ADDENDUM NO. 1

PROJECT: NORTHWEST CONSOLIDATED SCHOOL DISTRICT OF SHELBY CO.

TRITON CENTRAL HIGH SCHOOL RENOVATIONS -

DATE: May 4, 2023

REVISED FLOOR PLAN POWER

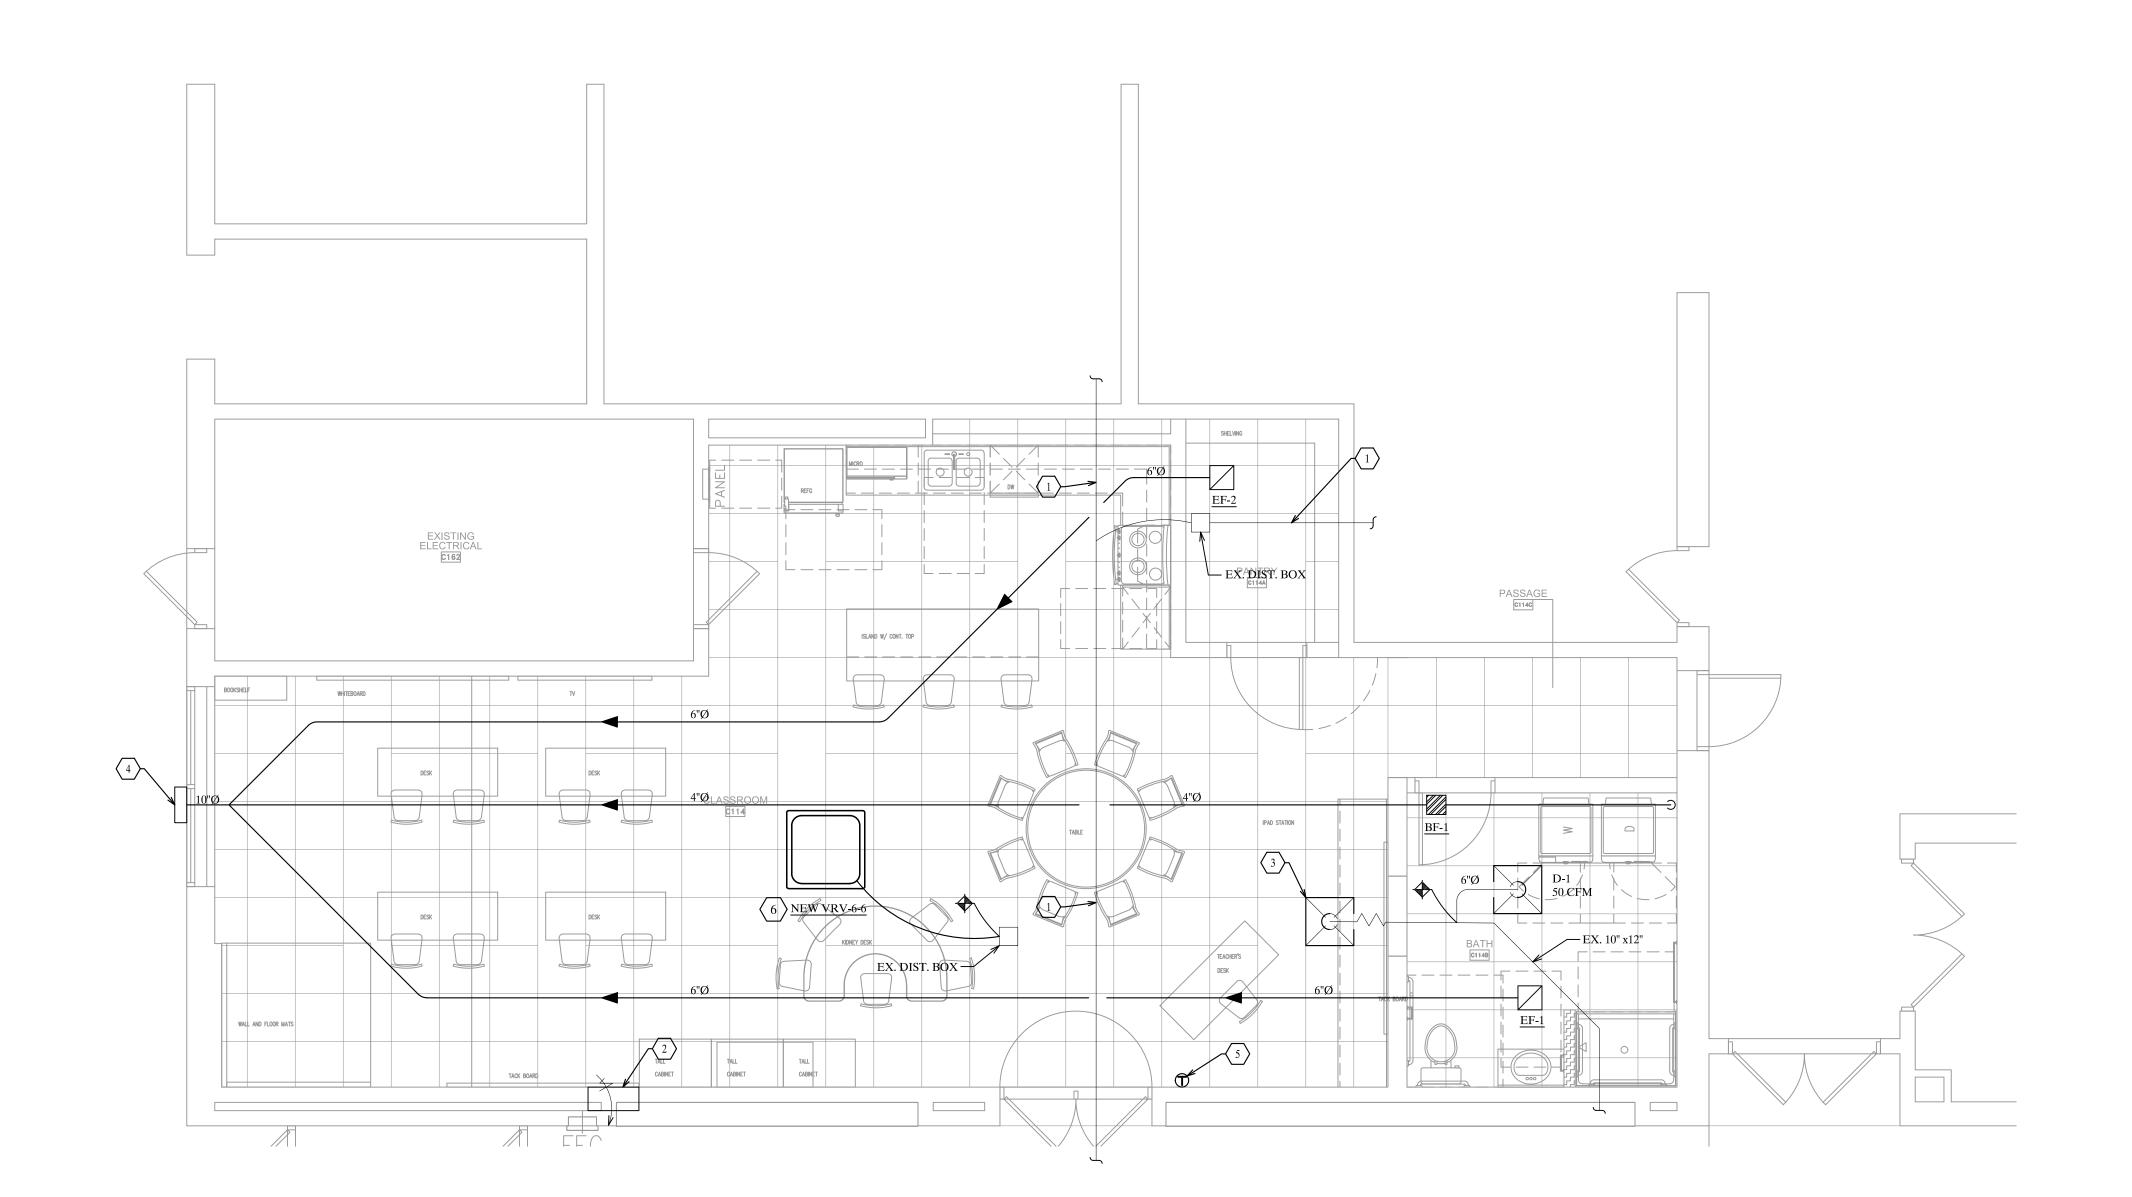
- 1. Sheets DMP-101, M101, E102, and E301 changed to indicate Alternate #2.
- 2. Sheet P101 changed to indicate existing 4-inch waste running in classroom from Owner provided drawings. Field verify location.

- 12. UNDER ALTERNATE #2, 20A, 208V-1Ø CONNECTION FOR NEW VRF. UNIT SHALL BE POWERED FROM EXISTING UNIT.

FRAME & DOOR ELEVATIONS

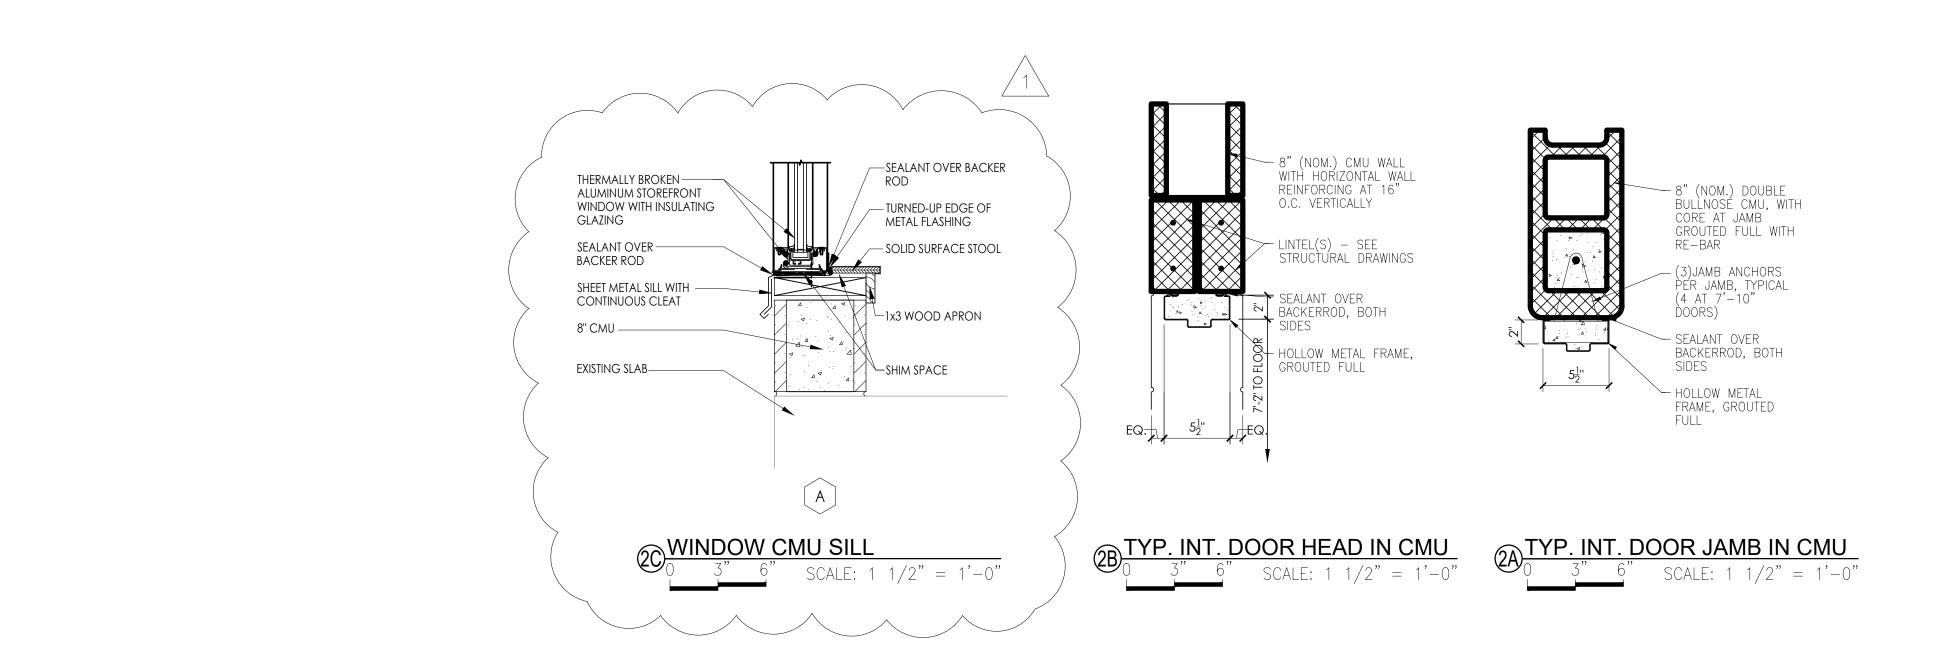
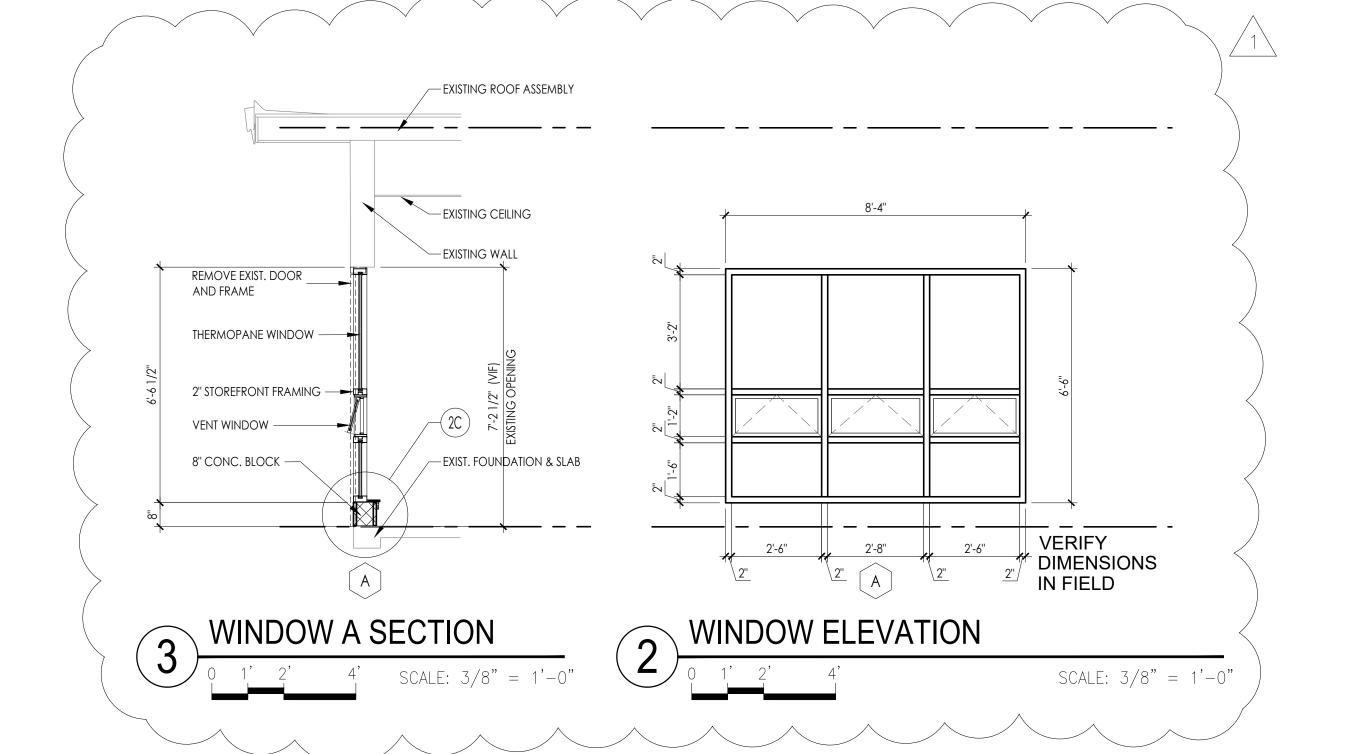
- a) Added window elevation and section.
- b) Added hardware sets to schedule.
